# St. Paul Orthodox Church

MAJOR PLAN 2023-104

Planning Commission, 1/15/2026

**TO:** PLANNING COMMISSION  
**FROM:** David Manhardt, AICP, Director of Community Development  
**SUBJECT:** St. Paul Orthodox Church  
MAJOR PLAN 2023-104  
PRELIMINARY/FINAL PLAN REVIEW  
**DATE:** JANUARY 7, 2026  
**COPIES:** BOARD OF COMMISSIONERS, T. PETRUCCI, D. MANHARDT, L. PEREIRA, ESQ.,  
J. ALDERFER, ESQ, A. TALLARIDA, E.BET, APPLICANT, SUB. FILE 2023-104

**SOUTH WHITEHALL TOWNSHIP**  
 AERIAL FIRE TRUCK TURNING TEMPLATE INFORMATION  
**THE PIDCOCK COMPANY**  
 CIVIL ENGINEERING AND LAND PLANNING ARCHITECTURE LAND SURVEYING  
 2451 PARKWOOD DRIVE ALLENTOWN, PENNSYLVANIA 18103  
**LARGEST EMERGENCY RESPONSE VEHICLE (2023 - MODIFIED)**

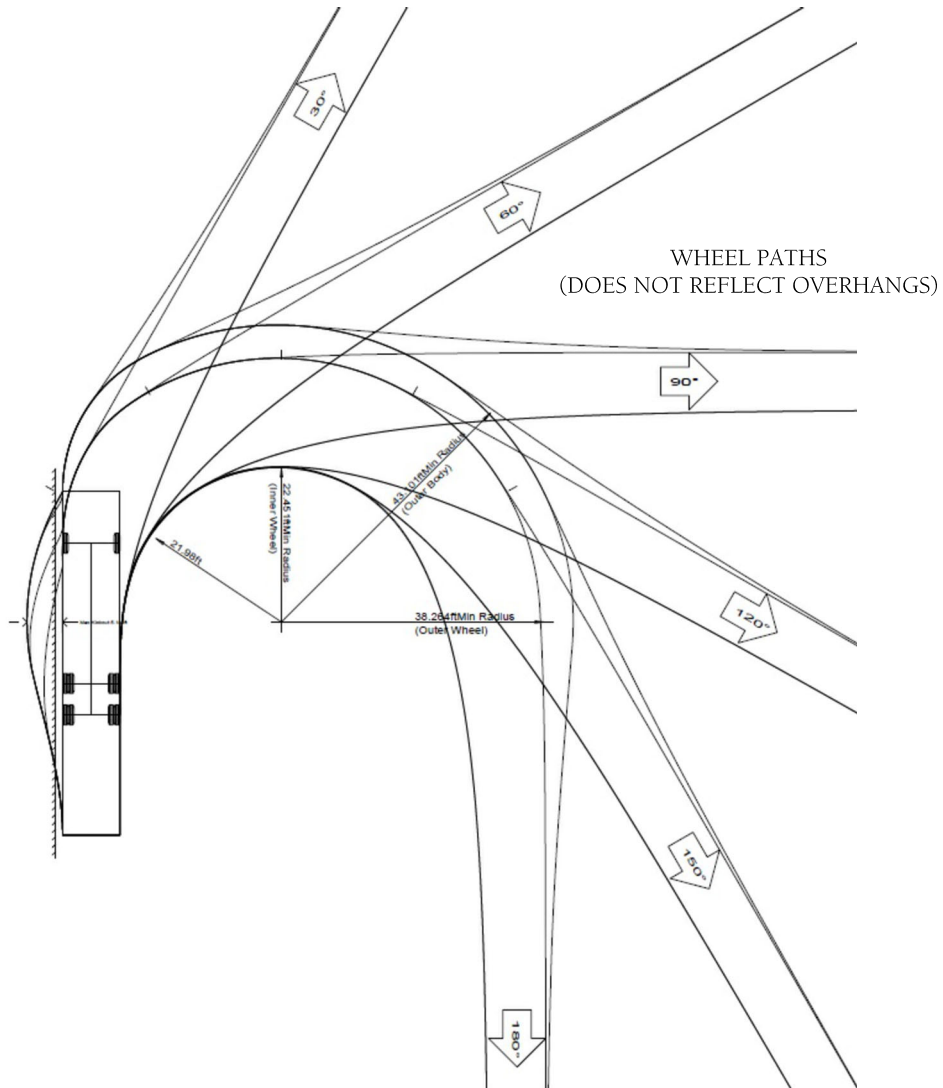
3. Check the Sign Tabulation and plan information for consistency (Sheet 3), SALDO §312-12(b)(42);
4. Provide delivery truck turning templates for the site. The templates should demonstrate the ability of trucks to maneuver through the site (to designated loading zone or delivery area). Also, revise the SWT Fire Truck turning template to meet the vehicle dimensions on the SWT Largest Emergency Response Vehicle Sketch (.pdf file attached);
